# Titan Connect Installation Instructions Addendum

## 2023 Ford, non-UIS

### TRANSMISSION RANGE SENSOR – PARK POSITION (Location: inside cab, right-side, behind glove compartment)

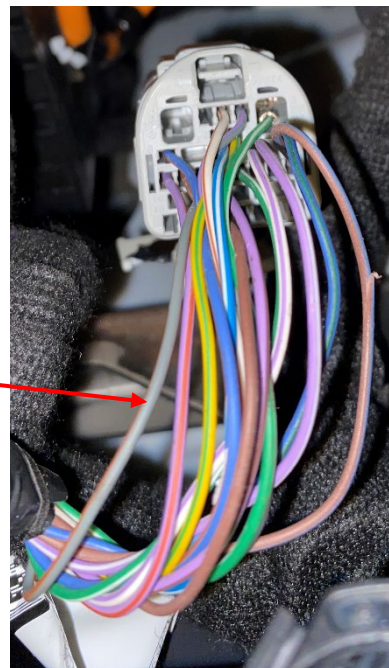
*These steps are to take place between step 5 and 6 of the Power Take-Off section (Titan Connect Installation manual, page 18).*

1. Locate SEIC/PTO connector with blunt cut pigtail harness.
2. Locate the wire coming from pin 13. The wire is gray with a brown stripe.
3. Use high quality tap connector (example: posi-tap) to splice extension to the pin 13 wire.
4. Using one of the pins supplied with harness, crimp pin to the extension wire.
5. Insert this pin into pin 5 of the housing supplied with harness.

### TACHOMETER OUTPUT (Location: inside cab, right-side, behind glove compartment)

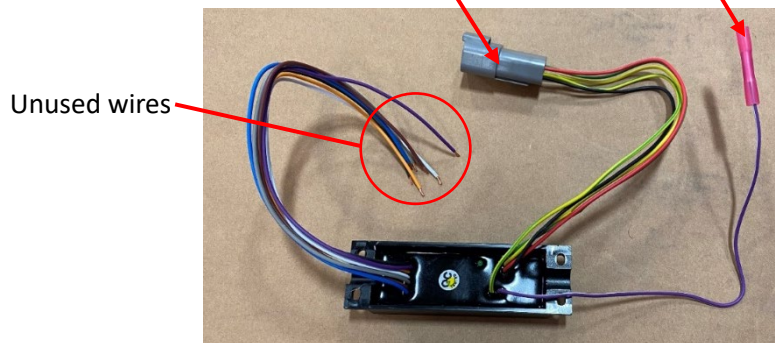
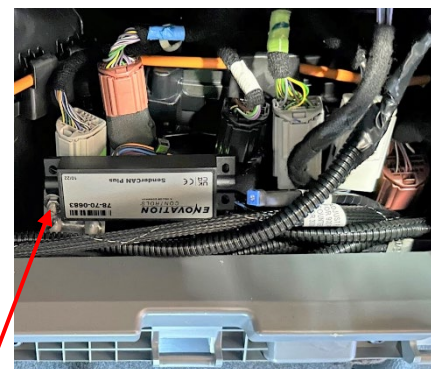
These steps are to take occur in place of the CAN Connections section (Titan Connect Installation manual, page 21).

1. Route the “C-KEYPAD” wires into cab through firewall to under the dash in front of the drivers seat.
2. Locate SEIC/PTO connector with loose ends.
3. Locate the wire coming from pin 9 of the SEIC/PTO connector. The wire is blue with a green stripe.
4. Connect the 4-pin plug connector attached to the SenderCAN Plus module to the plug connector “C-KEYPAD” from step 2. Use the included extension if needed.
5. Connect the purple (with white stripe) wire from the SenderCAN Plus module to the pin 9 wire from the SEIC/PTO connector. The SenderCAN Plus module comes already fitted with a connector.
6. All other wires connected to the SenderCAN Plus module are not used for this installation.
7. Store and secure the SenderCAN Plus module to the unused UIS mounting plate with the provided hardware. Store and secure any wires run during installation.

## PROGRAM INSTALLATION

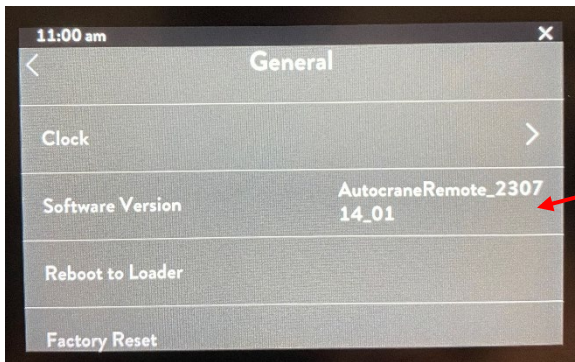
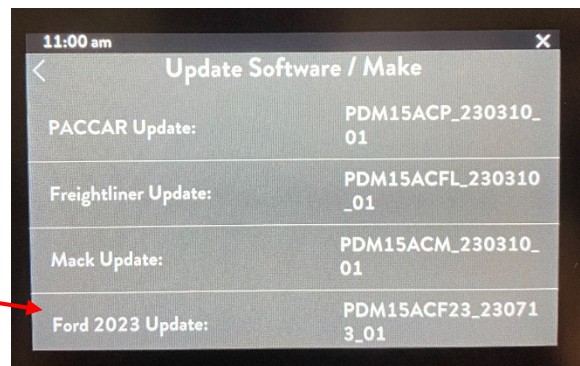
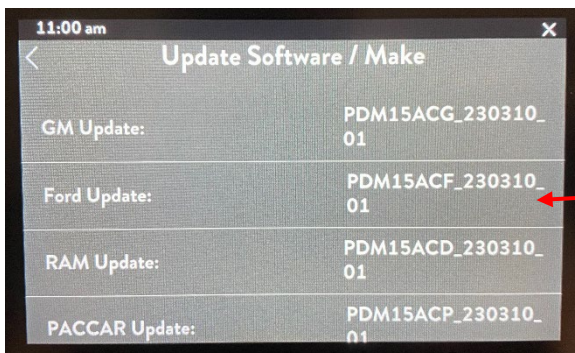
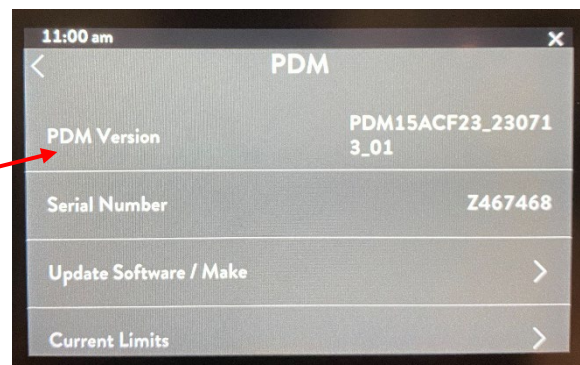
1. 2023 Ford chassis requires an updated Titan Connect program; AutocraneRemote\_PV500\_230714\_01.pv1 is the file name. Earlier versions of the Titan Connect program will not provide full functionality with 2023 Ford chassis.
2. On the LCD screen, in the General menu, the Software Version should read AutocraneRemote\_230714\_01 once the correct program is installed.
3. Be advised, there are two Ford options in this version of the program. For this install, be sure to select the "Ford 2023 Update." "Ford Update" should be used for 2022 chassis and older.
4. Once the proper update is installed, the PDM Version should read PDM15ACF23\_230713\_01 in the PDM menu.
